RE: Development Review Team (DRT) Summary for:  
Farm Bureau Insurance (Site Plan)

**RE:** Farm Bureau Insurance Site Plans

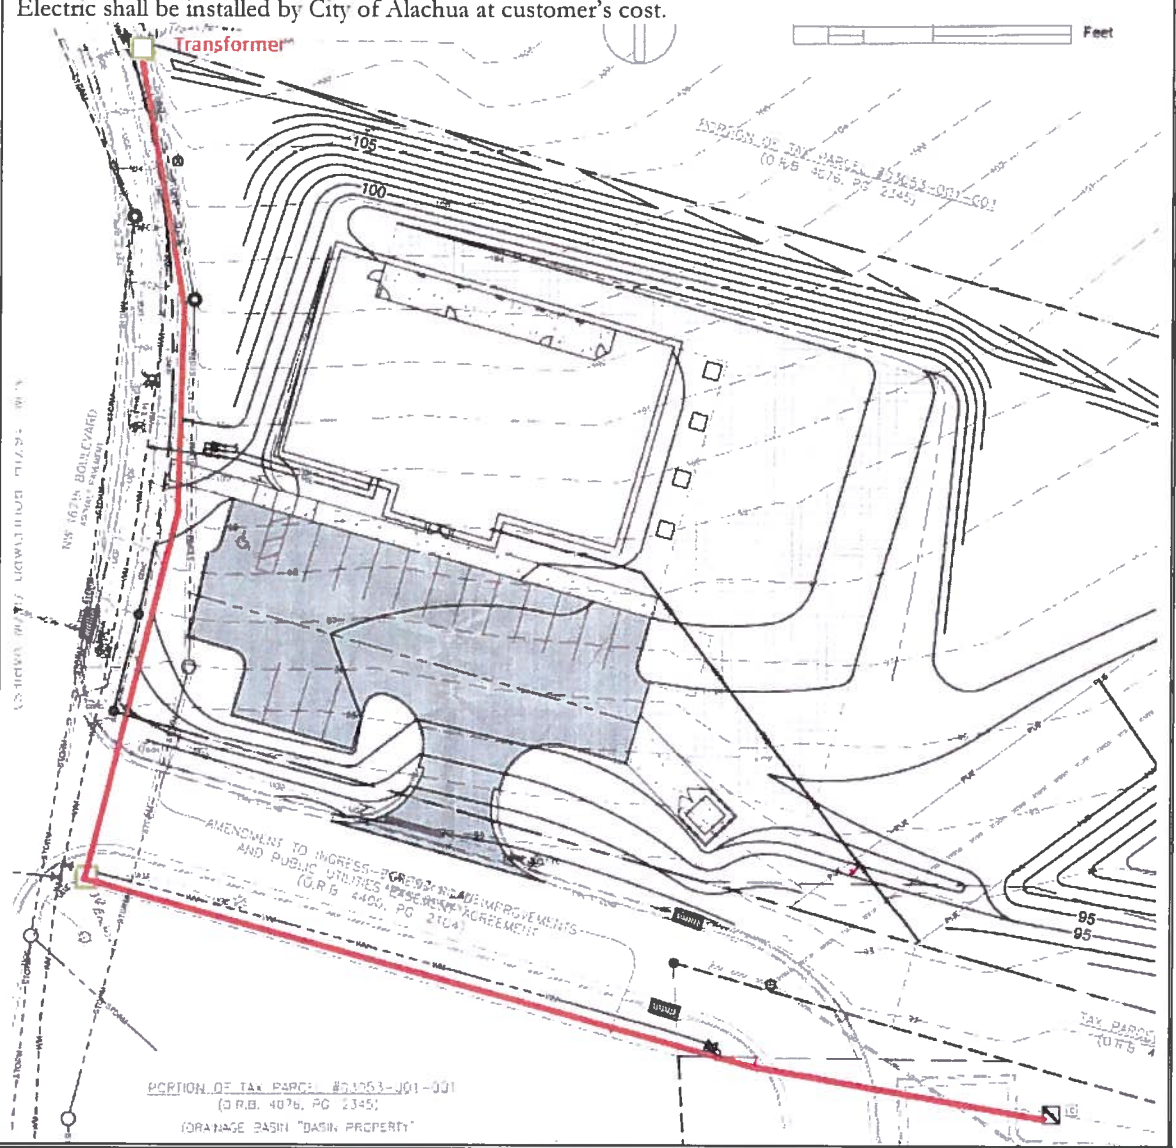
| NO.             | COMMENTS   |
|-----------------|--|
| 6.              | <p><u>Electric:</u><br/> Electric to be installed as shown below with source from existing transformer behind Hungry Howie's to new transformer located in northwest corner.<br/> Provide PUEs as required.<br/> Electric shall be installed by City of Alachua at customer's cost.</p>  |

#### Utility Easement No. 2 – Alachua Gateway

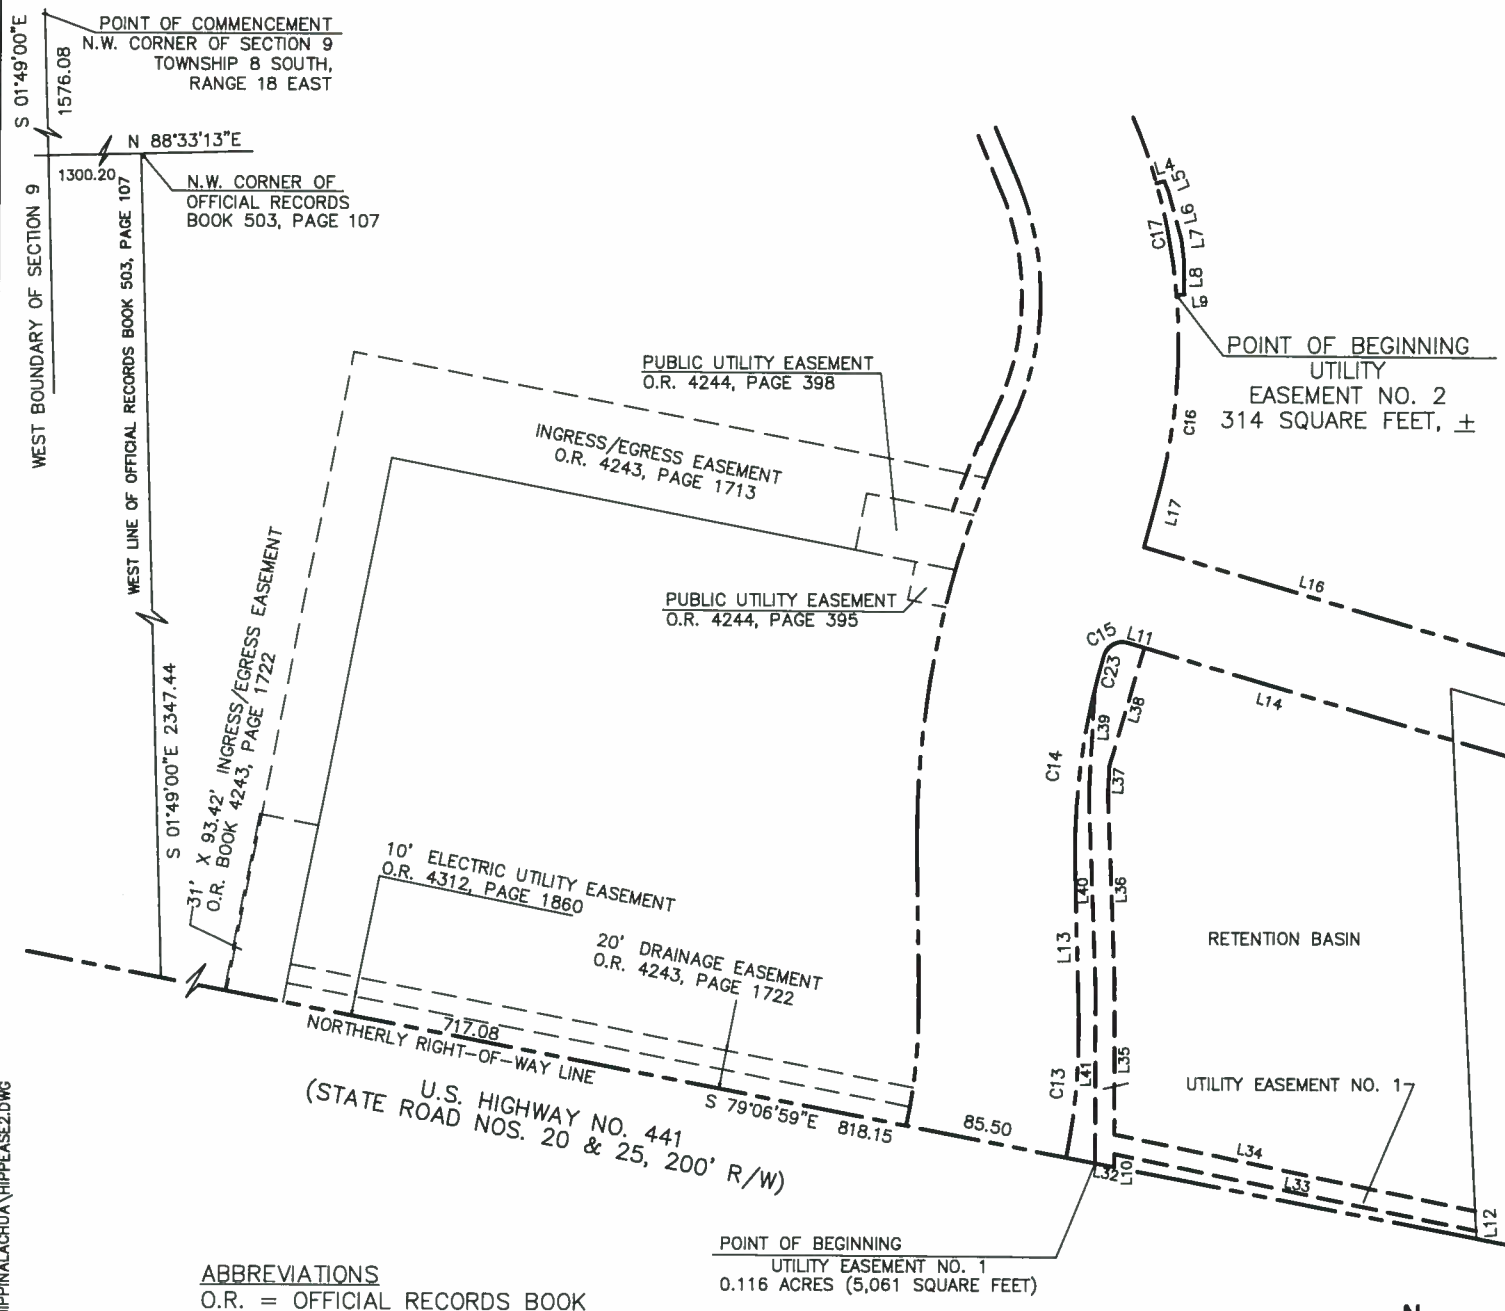
7. Site Plan application sheet should be updated to reflect new property line.
8. An easement will be required along the property's western boundary (along NW 167<sup>th</sup> Boulevard), if this easement is not granted by the current property owner before transfer of property. The sketch and legal description of this easement has been attached to this letter.
